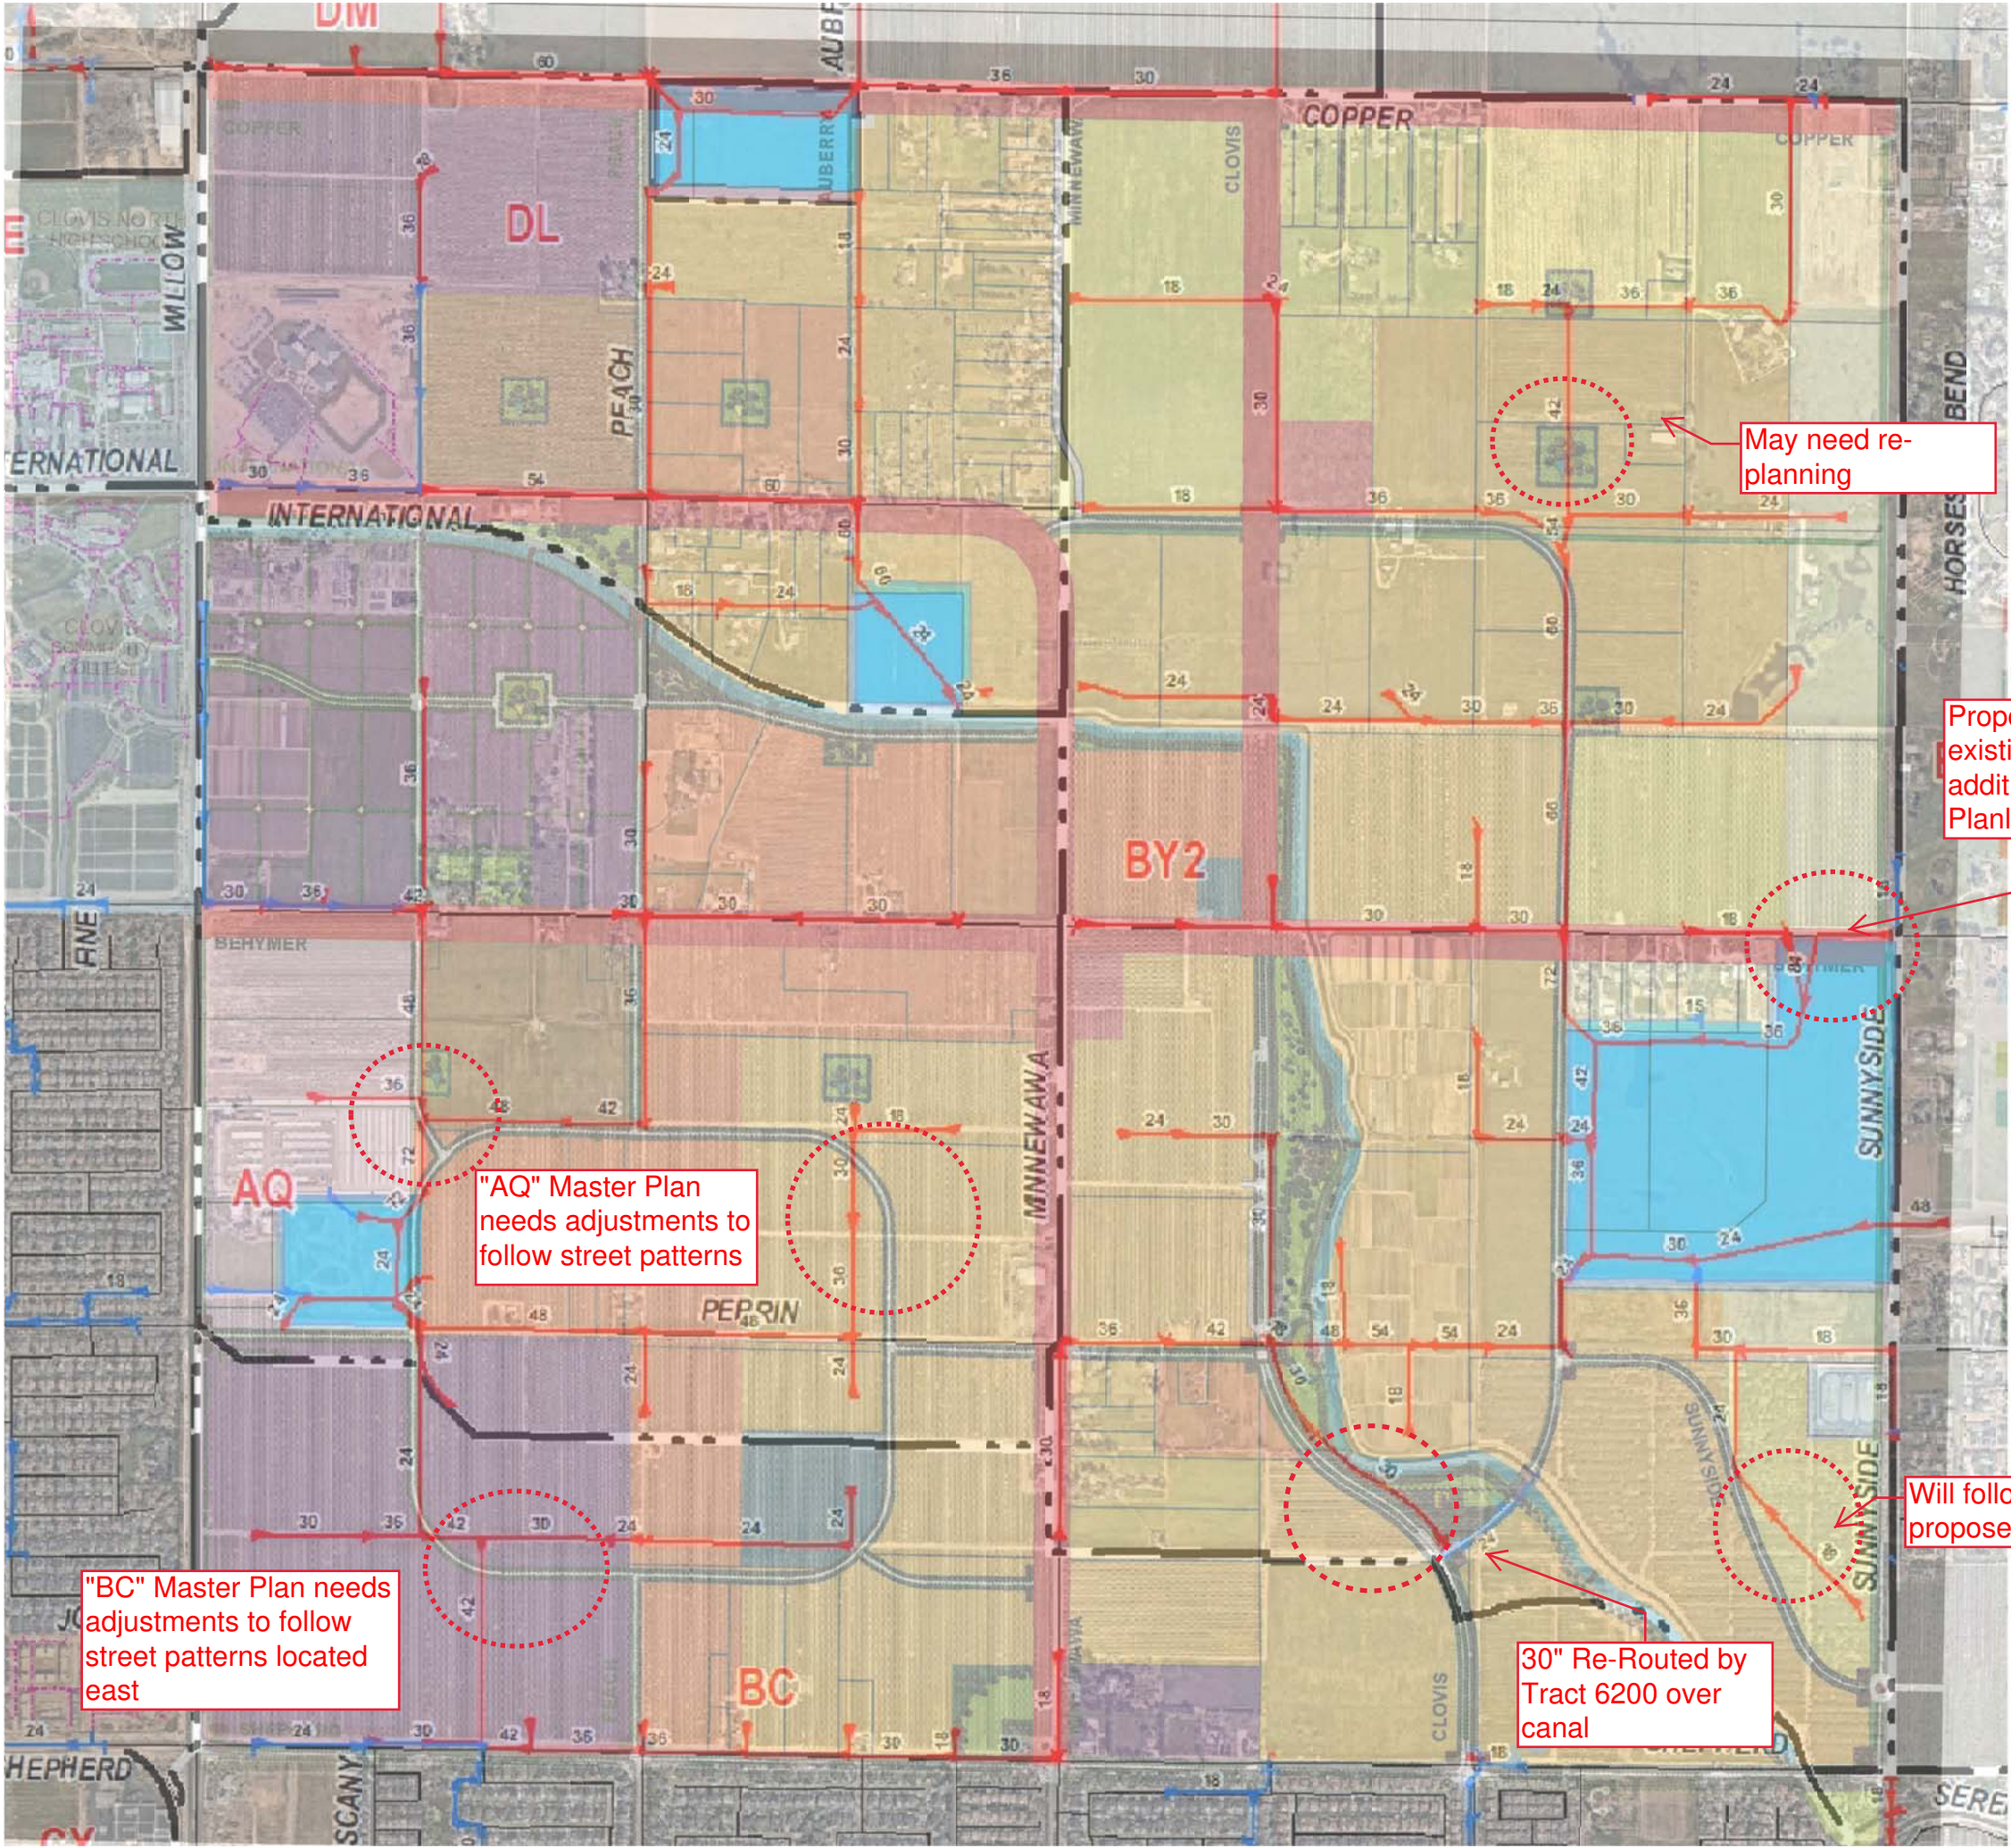
- Preferred alignment for storm drain placement shall be either north or east of street center lines.
- All streets with curb medians and 11' or 12' width lanes will typically be placed 6' off curb face.
- For street sections with 11' turning lanes, prefer to be 10' from the centerline.
- Contain FMFCD pipe within the center of travel lanes whenever possible to minimize the need for multiple lane closures should our facilities need to be maintained.

May need re-planning

Proposed R/W will follow existing fence, no additional R/W needed per Planline

"AQ" Master Plan needs adjustments to follow street patterns

"BC" Master Plan needs adjustments to follow street patterns located east

30" Re-Routed by Tract 6200 over canal

Will follow proposed Tract
